UNITED STATES PATENT AND TRADEMARK OFFICE

APPLICATION NO.	FILING DATE	FIRST NAMED INVENTOR	ATTORNEY DOCKET NO.	CONFIRMATION NO.
10/820,636	04/08/2004	Sridhar Ranganathan	17,872	8821

Office Action Summary	Application No. 10/820,636	Applicant(s) RANGANATHAN ET AL.	
	Examiner Keshia Gibson	Art Unit 3761

DETAILED ACTION

Fig. A: Examiner's markup of Gertzman's Fig. 2 to identify subtended angle.

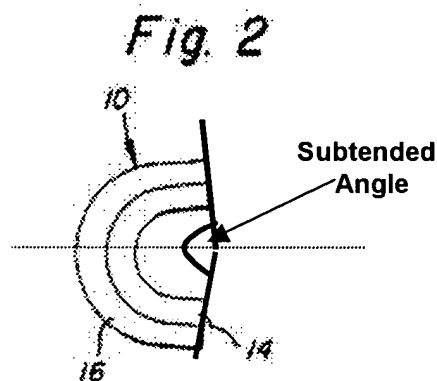
In regard to Claims 7, in Fig. A below, the structure 10 of Gertzman et al. is marked up based on examiner's understanding of "subtended angle." As can be seen in Fig. A, the absorbent structure 10, has a subtended angle of about 180 degree or less.

Furthermore, this property is considered to be inherent based on the same structure/same property as provided in the discussion of Claim 1.
